# **Annex 120G (C2M) Comment Resolution**

P802.3ck Editor-In-Chief

IEEE P802.3ck Task Force

May 2021

Figure 120E-13—PAM4 eye measurements

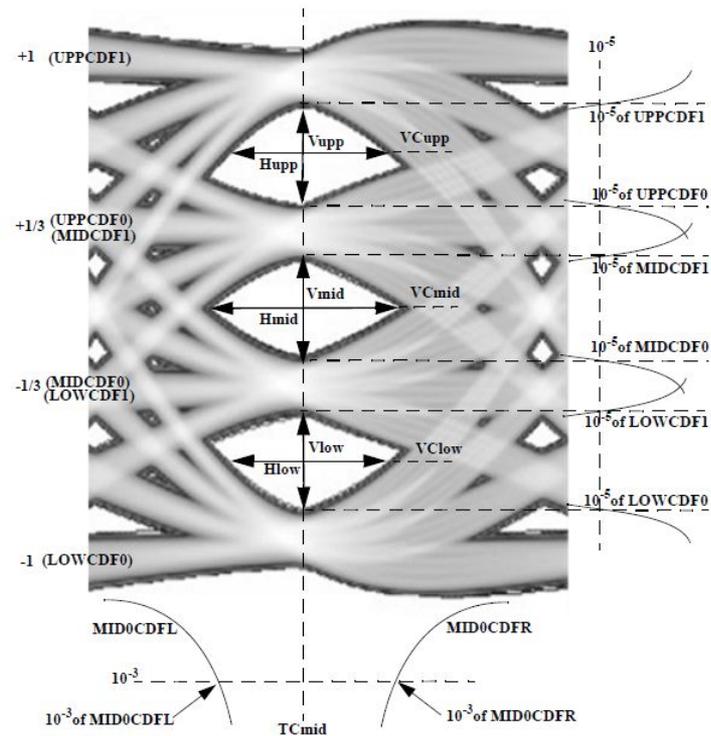
The new C2M test procedure no longer require eye opening measurement with introduction of timing window  $t_x = \pm 50$  mUI, given the amount of change it will be very confusing for the reader to follow the procedure!

Please include a figure and full procedure in CL120G instead of referencing 120E

The methodology in this subclause leverages the methodology already documented in 802.3-2018 Annex 120E. There are only a small number of clear exceptions. Replicating the entire methodology is not warranted. Also, it is helpful to refer to existing test methodology familiar to test implementers. The relationship between TCmid (in Figure 120E-13) and  $T_s$  can be easily inferred from the exception (the CDF of the signal voltage is accumulated over the time interval  $t_s \pm 0.05$  UI instead of "within 0.025 UI of time TCmid").

Figure 120G-7—Example module output test configuration

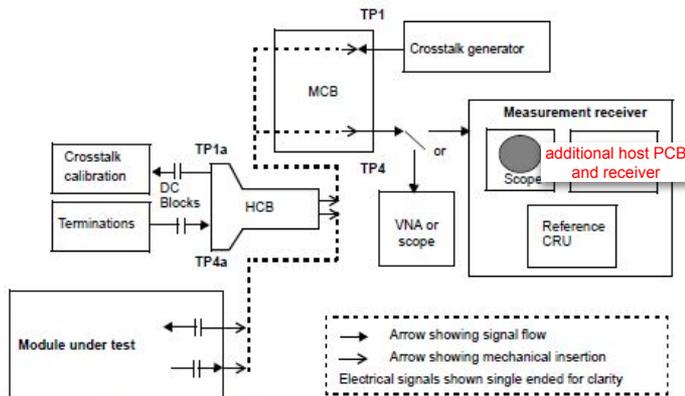
Add note to the table that above PCB length assumes an MCB loss of 2.4 dB, please also list the PCB losses in dB instead of every reader trying to calculate  
 80 mm = 3.1 dB  
 160 mm = 6.6 dB  
 244.7 mm = 9.6 dB

The location of the measurement host PCB is not shown Figure 120G-8, but should be part of the measurement receiver between the MCB and the reference receiver.

It would be helpful to note the assumed MCB insertion loss and the insertion loss associated with each of measurement host PCB lengths listed in Table 120G-5. However, it is not necessary to provide the sum of the two. Specifying host PCB length to finer precision than 1 mm is not necessary.

In Figure 120G-7, change "reference receiver" to "host PCB and reference receiver".

In Table 120G-5, add an extra column for host PCB insertion loss.

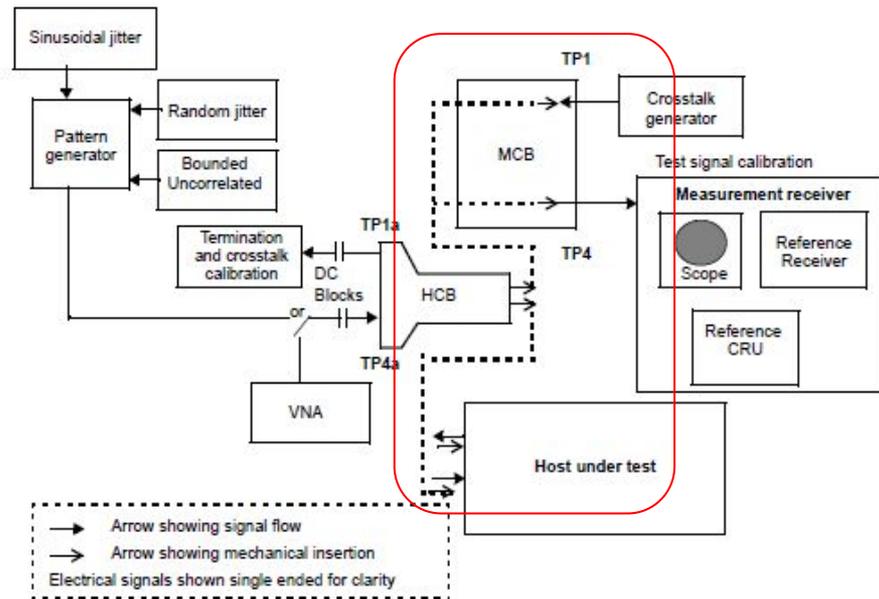
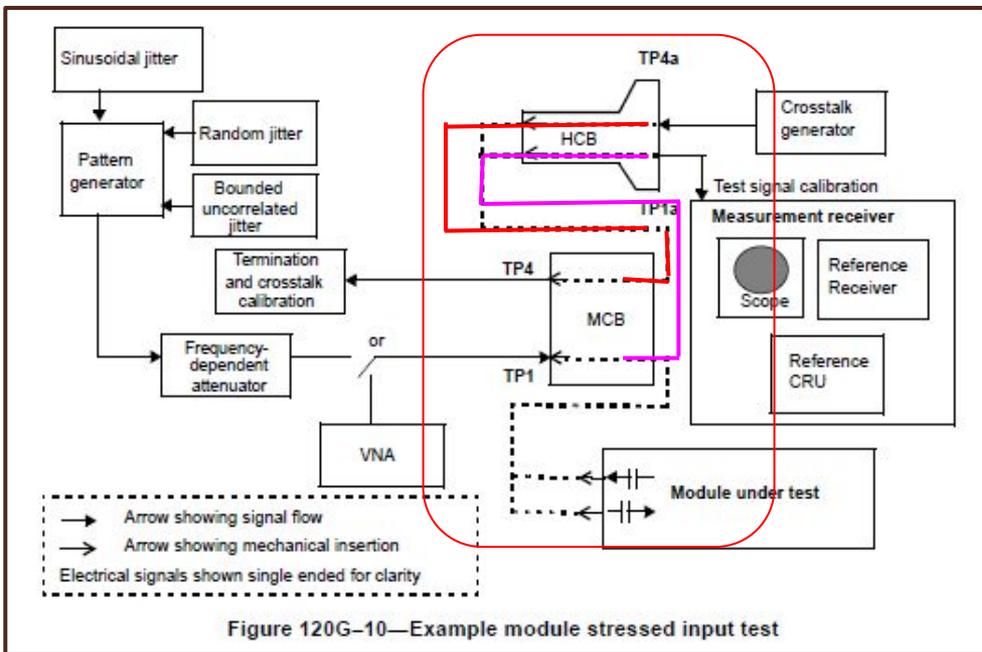
Also, in Figure 120G-10 and figure 120G-9, the connections of the HCB and module under test to the MCB are incorrect.

In Figure 120G-9 connect the dashed line from the HCB TP1a path to the MCB TP1 path and connect the module under test input path to the MCB TP4 path.

In Figure 120G-10 connect the dashed line from the MCB TP4 path to the HCB TP4a path and connect the host under test input path to the HCB TP1a path.
